STAFF REVIEW  
COMMITTEE REPORT

Application: New Warehouse Facility – Westfield Inc.  
20 Pomerleau Street (Tax Map 2 Lot 81 and 81-5)

**Minor Site Plan Review**

**SITE PLAN**  
1-UNIT WAREHOUSE FACILITY  
POMERLEAU STREET  
BIDDEFORD, MAINE

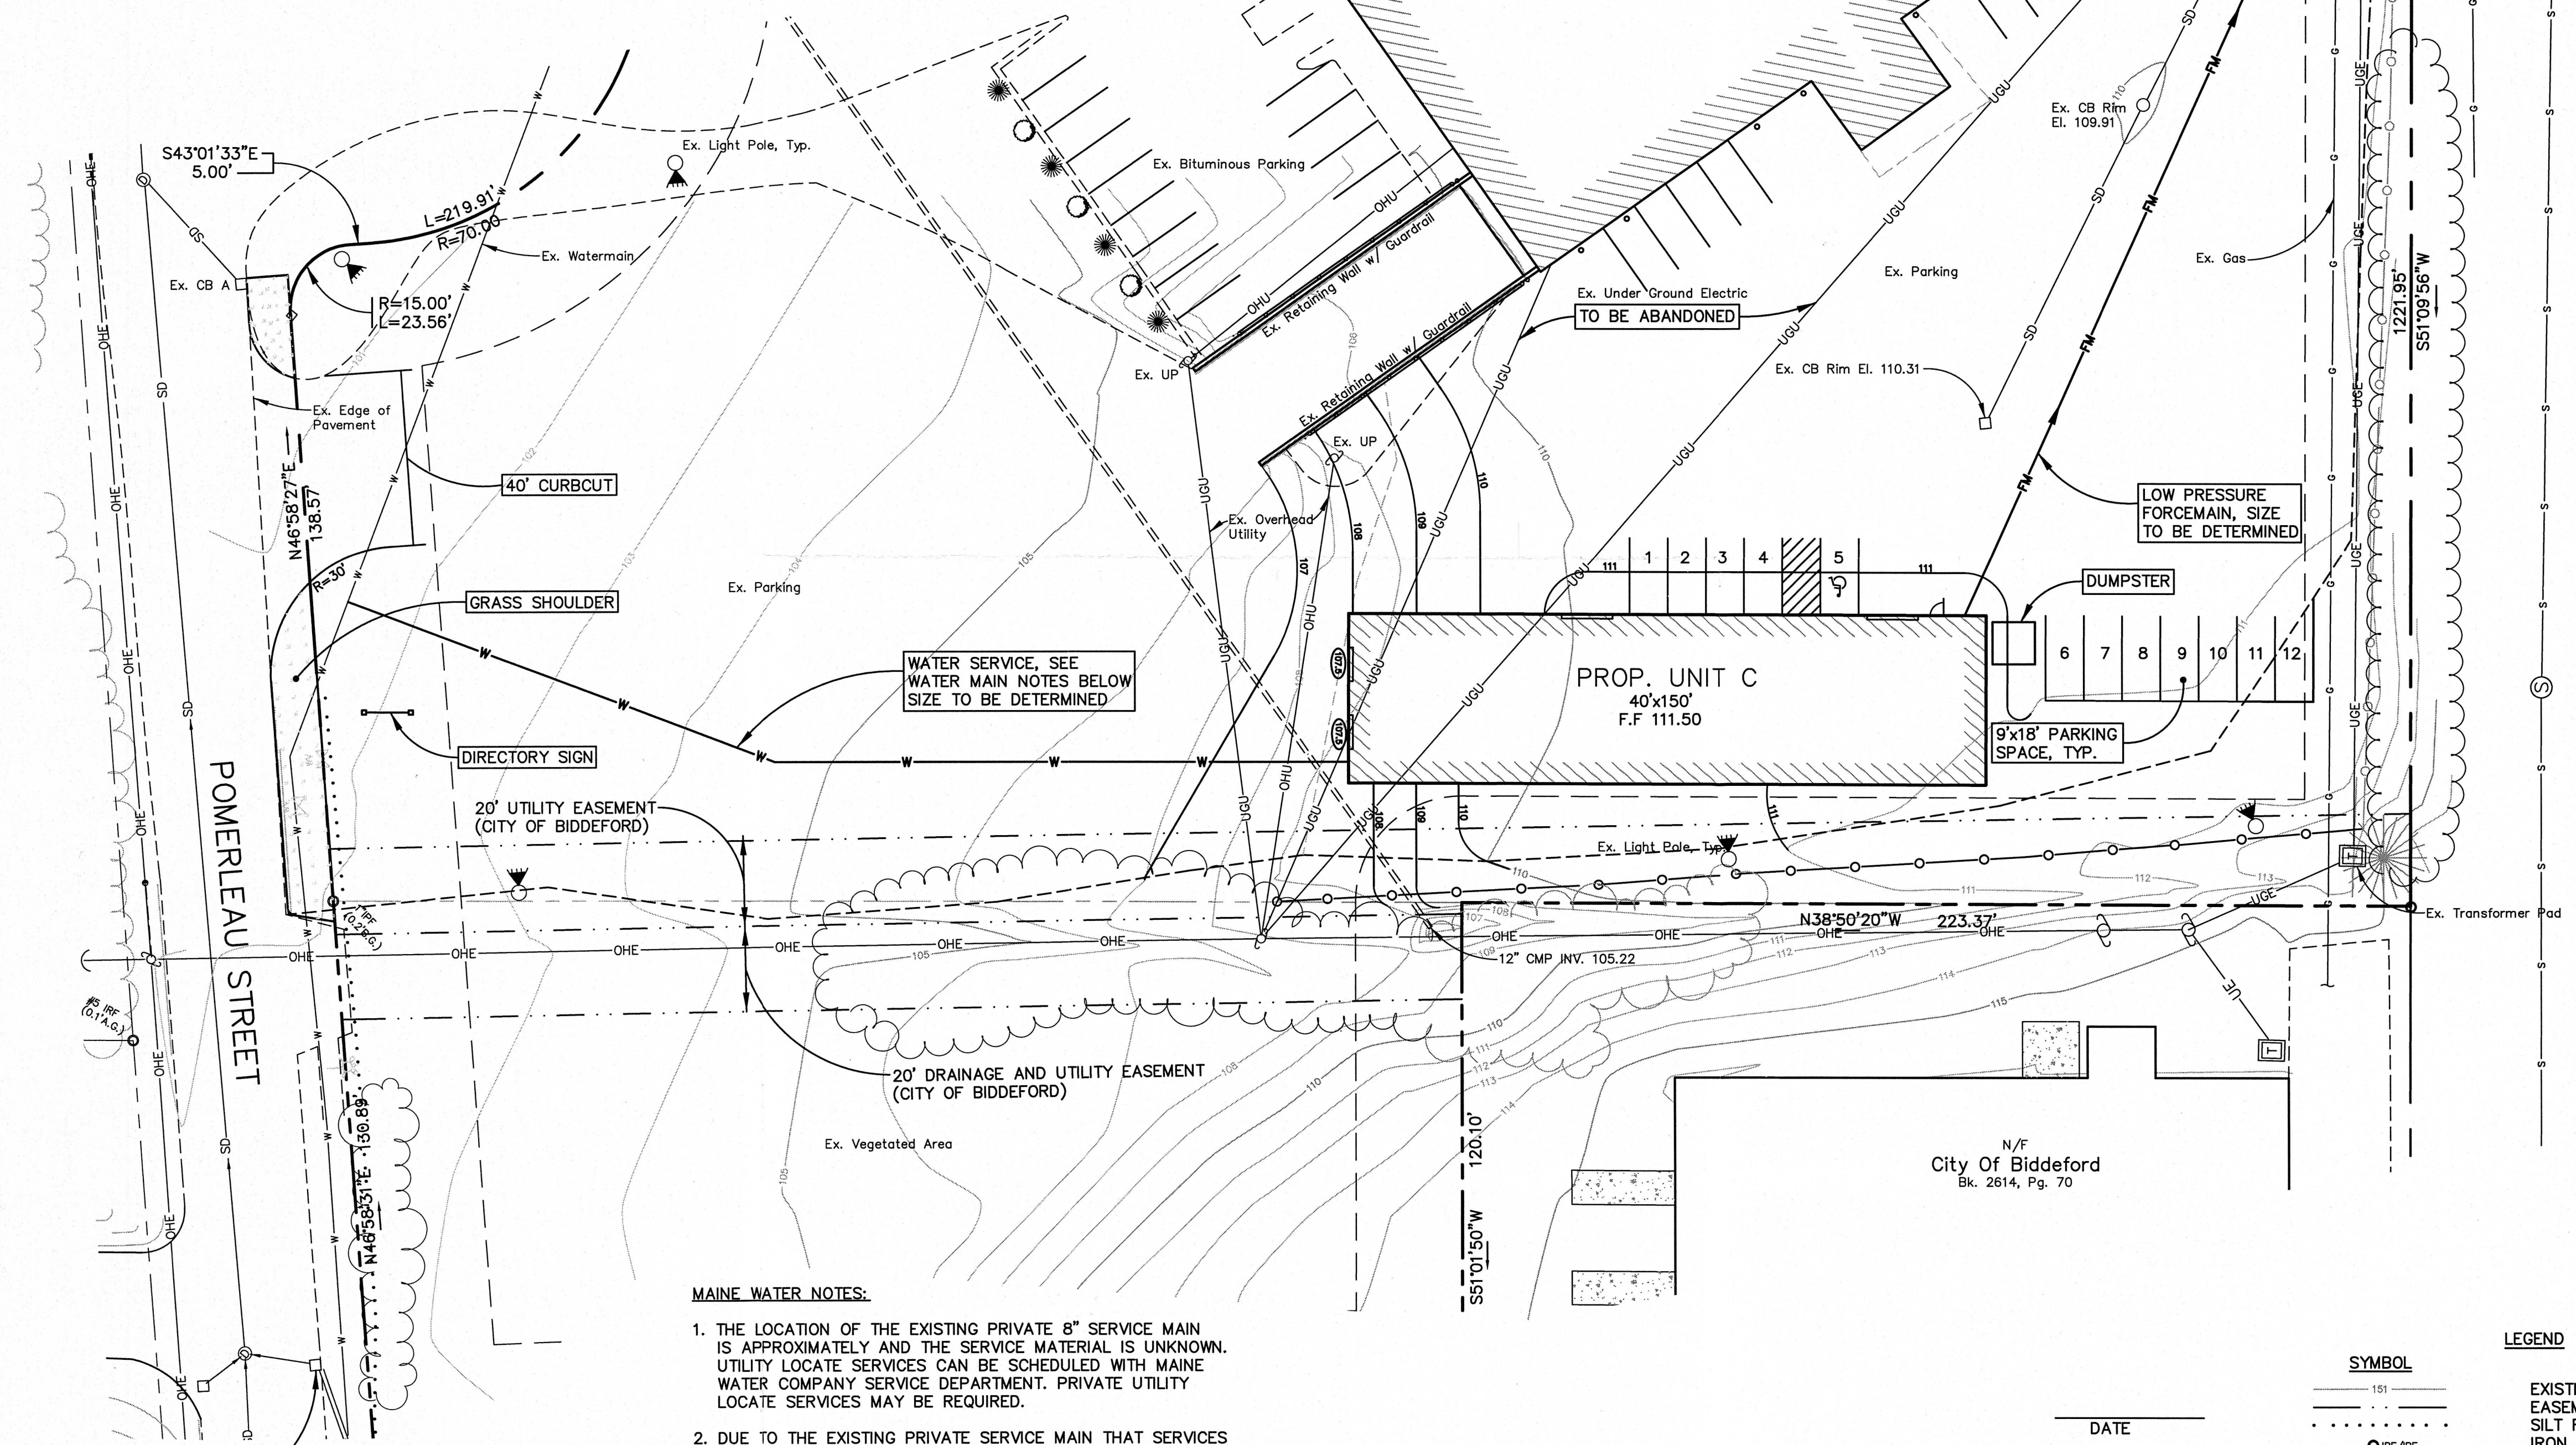
1. Pavement within the front yard setback. The existing driveway is approximately 75 feet wide; the standard (Chapter 66 Section 111) is 40 feet wide for Type II-A. As approved in the 2020 site plan, the driveway entrance width is planned to be reduced to conform to the standard. Adjacent to the entrance is existing gravel pavement located in the front yard setback, that does not conform to Article XI Site Plan Standards (Sec. 5.B.4.f.) and Article VI Performance Standards (Sec. 49.A.5). It is recommended that the applicant takes the opportunity while constructing a new entrance to remove the gravel paving from the setback to conform to the standard. In addition, the limits of the proposed parking spaces needs minor adjustment to address conformance of space #12 located within the setback.

2. Building Façade. Information on the proposed building façade was not submitted and it is understood that the design does not use masonry materials as required in the Industrial-3 zone, Section 5.B.4.a.2 of the Article XI Site Plan Review (Part II). As anticipated by the provision, the applicant should demonstrate to the Committee, as done in 2020 to the Planning Board, that a masonry building façade is not needed here so the Committee can determine if the metal siding proposed will conform to the provision. Building elevation, renderings and siding information has been submitted.

3. Landscape Design. There is no landscaping proposed. The last review in 2020 considered compliance to Section 49.A.10 and 5.B.4.f.2 of Article XI Site Plan Review (Part II), where maintained landscaped areas are anticipated, and that the I-3 Zone (Art. V) anticipates more *stringent* landscaping standards. The proposed development is narrower in scope as what was previously reviewed, and the Committee should determine if plantings are applicable at this point in time.

4. Maximum Lot Coverage. The standard (75% Maximum) is noted on the plan, however, the actual coverage proposed is not. As previously provided in 2020, a plan note that identifies the existing coverage and the proposed coverage should be provided. Though it is not anticipated that the proposed development will exceed the maximum allowed, it is pertinent to provide the updated coverage that addresses the minor increase of the proposed parking spaces #11 and #12.

5. Electrical and telephone Utilities. The proposed development plans for overhead lines, though it's not clear where the new service is located. The existing building is serviced by underground utilities. The standard under the Site Plan regulations (Section 5.B. Site Design Criteria) is to place these utilities underground where practicable. The applicant should address, and the Committee should determine if its practicable or not.

6. Lighting. The applicant should elaborate on proposed lighting (not clear if it is proposed) and should demonstrate if the renovated site will be sufficiently lighted while avoiding glare past the property and on to the street.

7. Solid Waste. A dumpster location is depicted on the plan out of view behind the proposed building.
8. Snow Storage. This is typically identified on the plan and doesn't appear to be. In 2020 the City requested a Winter Maintenance Plan be prepared as part of non-residential development. The applicant addressed snow storage in a Winter Maintenance Plan in 2020. The plan should be updated.

- a. It is difficult deciphering what is existing vs. proposed vs. to-be-demolished since the majority of linework is black and bold; recommend additional callouts and screening existing layers in a consistent manner (some ex. water linework is bold, some screened)

- b. Legend is missing significant amount of linetypes shown on plans, making it unclear what each linework represents
- c. The property line dividing Lot 81 and 81-5 is not shown

- d. The limits of disturbance should be shown and square footage noted on the plan
- e. The net difference in impervious cover should be noted on the plan

- f. Hatches should be included on the plan, showing what areas will be paved, proposed building, landscaped, gravel, etc.
- g. The existing parking area adjacent to Pomerleau Street looks like gravel according to Google Streetview; recommend pre & post-construction photos

- i. Is it unclear where new asphalt is proposed vs. new vegetation vs. existing gravel
  - ii. It is unclear how the site will be accessed and what the driveway apron will look like (i.e. where will trucks maneuver, location of drive aisles, etc.)

- h. No soil erosion measures are shown; silt fence, construction entrance, catch-basin/inlet protection is needed
- i. Permanent rip-rap/inlet protection should be provided for the ex. 12" CMP culvert within the ex. southern swale

- j. No details provided at all; pavement, striping, signage, ADA, E&S, dumpster, and utility details should be provided
- k. No dimensions provided for: proposed building, building setback from property line, drive aisles, parking layout, ADA parking, etc.

- l. Unclear if a fence is being proposed along the southern drainage swale
- m. Existing utility sizes should be noted on the plans (water, storm, sewer, and gas)

- n. Inverts should be shown for existing storm and sanitary sewers
- o. No force main sizing, material, or details shown; no proposed sewer manhole details, sizing, or inverts provided

- p. Proposed water structures (tees/fitting/valves) should be shown and called out; confirm if an additional water meter is required
- q. Confirm where the proposed building's roof runoff will drain to; roof drain locations and tie-ins should be shown as applicable

- r. Confirm/show proposed building's electrical connection
- s. Recommend bollards be installed at proposed building corners for vehicular/truck protection; confirm if loading docks will be striped

- t. Drawing is signed by a surveyor, not a licensed engineer; confirm as needed
- u. Drawing scale (1" = 25') is not a standard engineering scale
- v. Drawing note #20 claims a Salt/Winter Management Plan was submitted. Not found in submittal package; confirm
